FREEDOM HILLS SUBDIVISION
SAN ANTONIO, TEXAS
MASTER DEVELOPMENT PLAN

SHEET
C6

Re: Freedom Hill Subdivision

MDP # 033-06

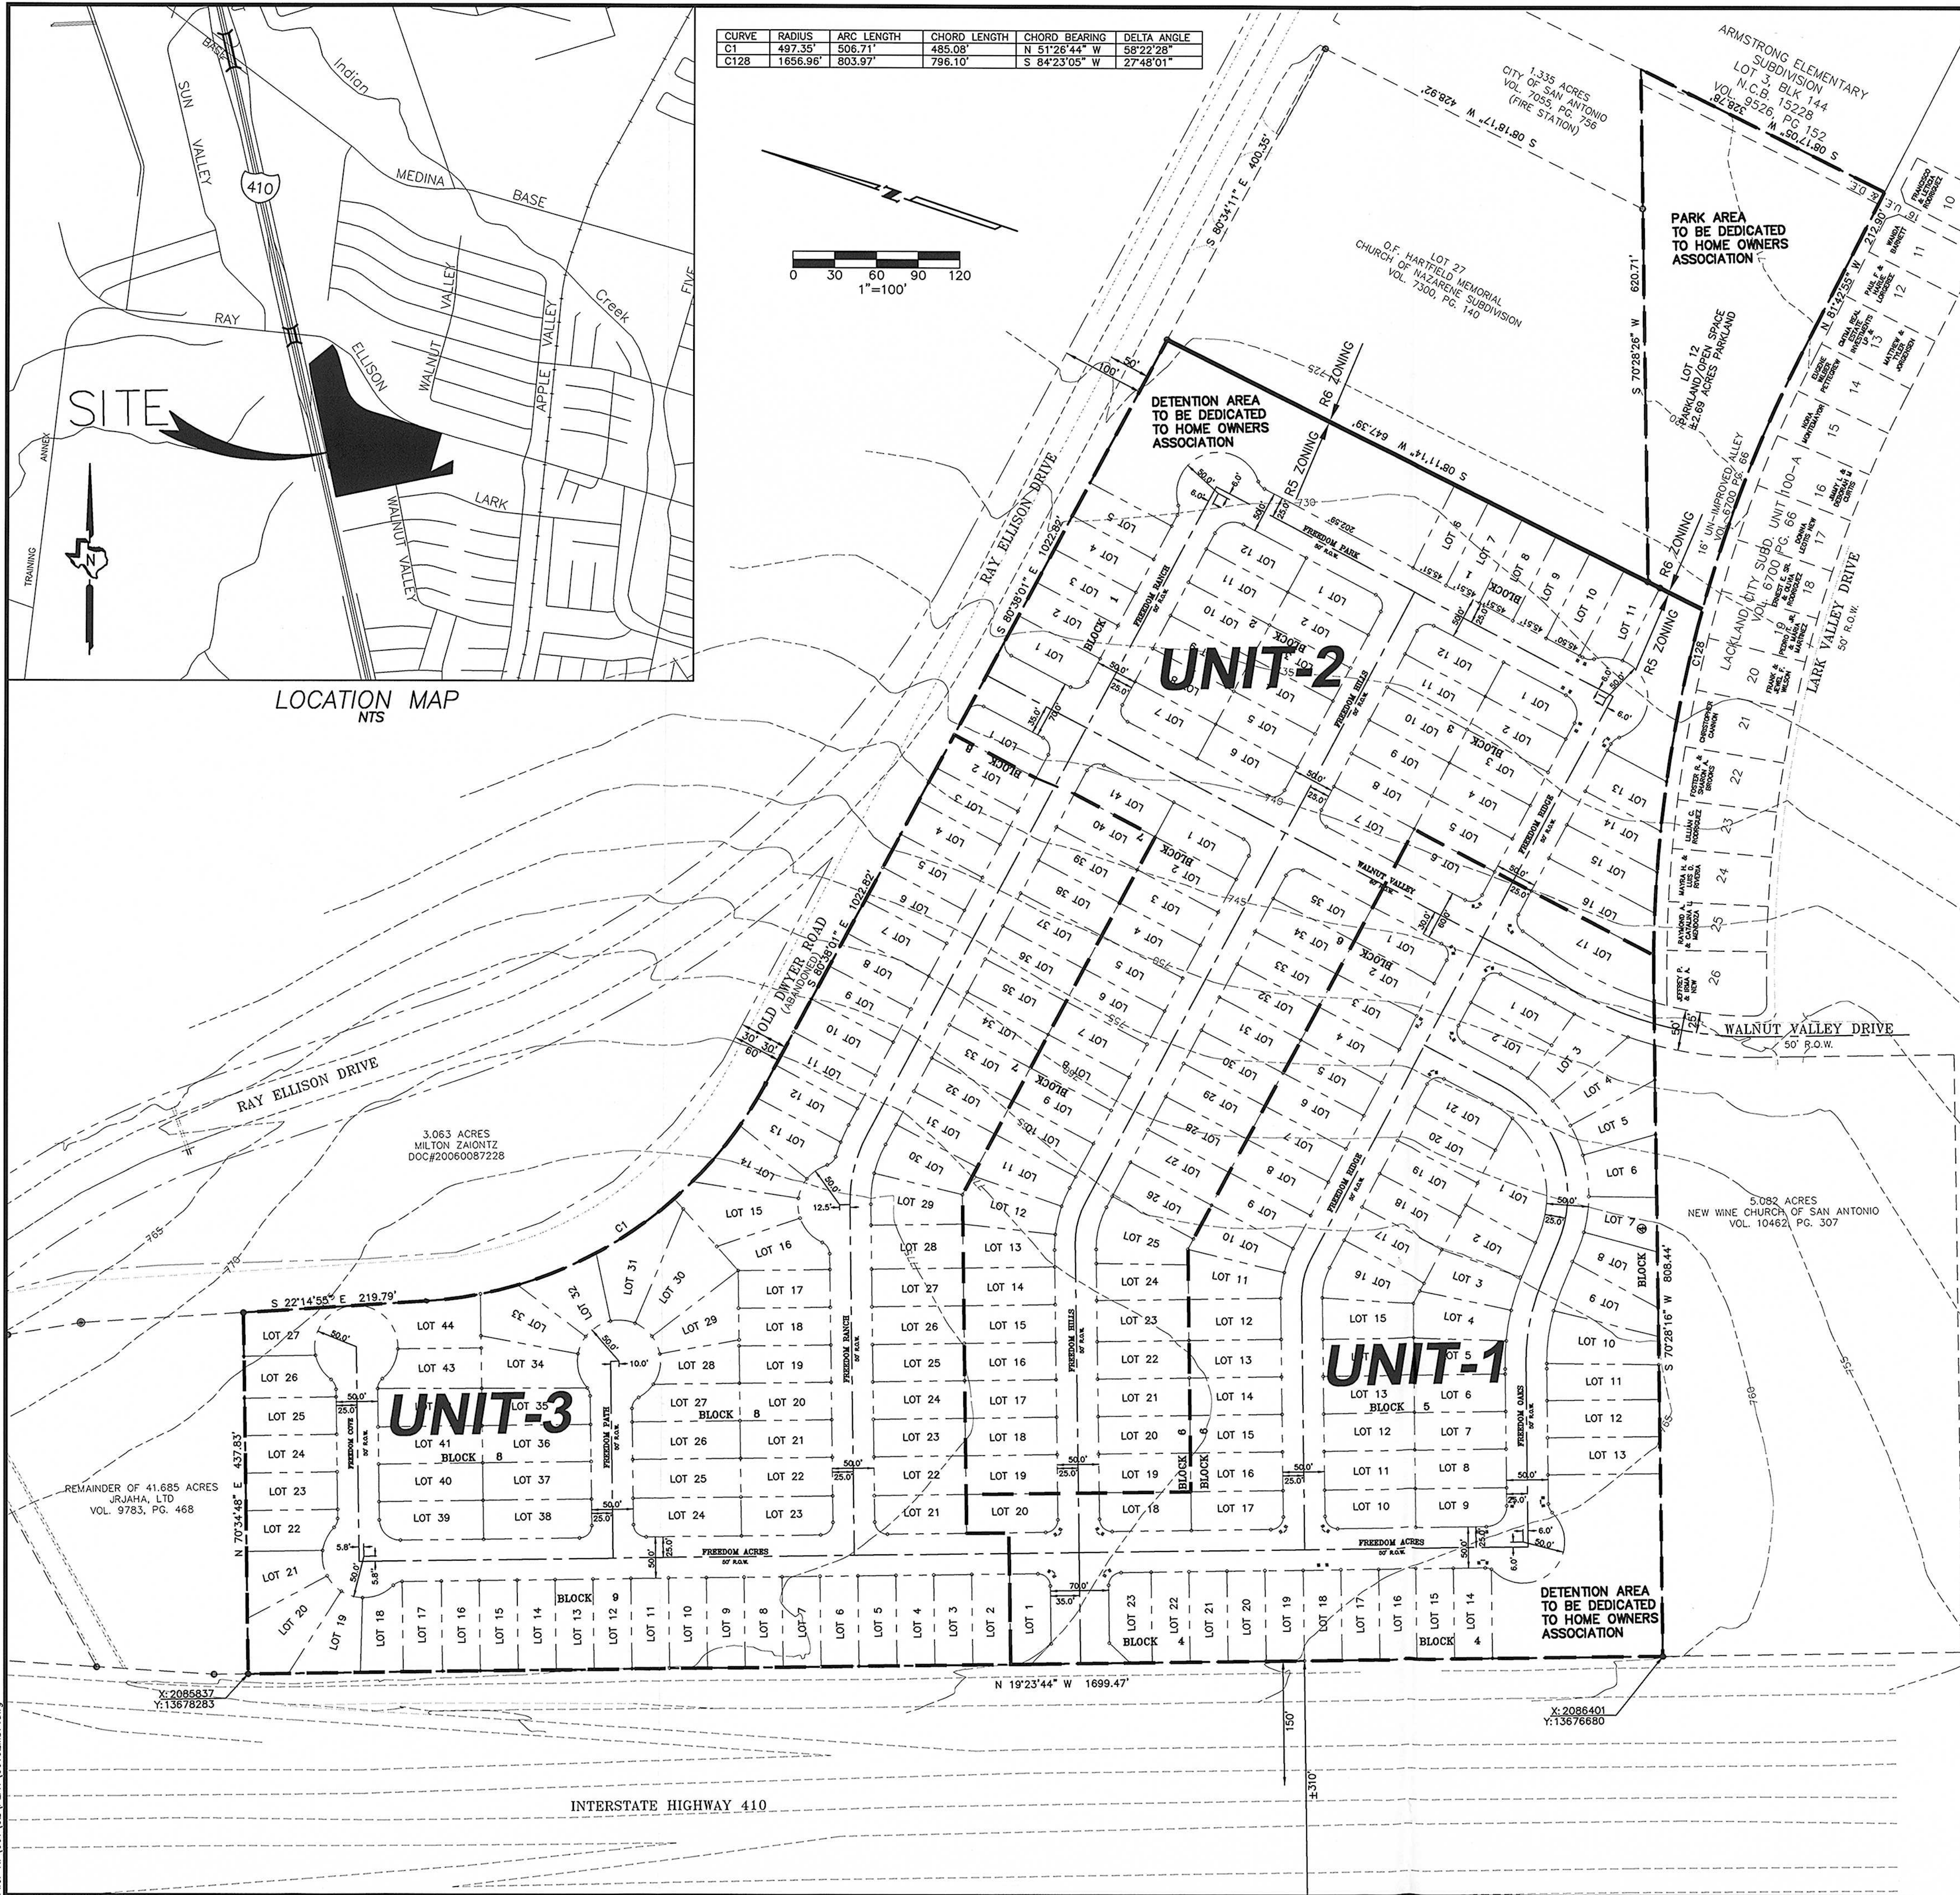
- In consideration of public safety and convenience, excessive grades by reason of topography should be avoided in street layouts and arrangements.
- Any access and R.O.W. issues along state facilities will need to be resolved with the **Texas Department of Transportation (TXDOT)**. For information about these requirements you can contact TXDOT at 615-5814.

- **Trees** approves with the following conditions:
 - 2003 Tree Preservation ordinance standards per UDC 35-523 – a Tree Preservation Plan was approved under A/P 1176116. Any changes to preservation plan must be submitted with a \$75 fee and approved by staff.

- It will be expected that you will plat all of the property depicted in your Master Development Plan (M.D.P.) to include floodplains, drainage areas and open space.

- I would encourage you to work closely with the school district, so that they can plan accordingly.
- **Parks** approves with the following conditions:

Freedom Hill is a proposed subdivision with 230 single-family residential units. UDC Section 35-503, Table 503-1 states that single-family development is required to provide 1 acre of park/open space per every 70 dwelling units. The requirement for this development is 3.3 acres. This subdivision provides 2.7 acres of park dedication plus 0.75 acres credit for the construction of an athletic court. Thus, the total amount of parkland dedication is 3.5 acres.

- The parkland provided shall be shown as "Park" or "Open Space" on a plat; UDC section 35-503(e) *Designation of Parkland*.
- The parkland provided is dedicated to the Home Owners Association.
- Parkland dedication must be platted by the second phase of residential development; UDC section 35-503(f) *Development Phasing*.
- All amenities comply with standards and specifications found in UDC section 35-503(h) *Credit for Park Facilities* and Table 503-4 if any credit is to be awarded.
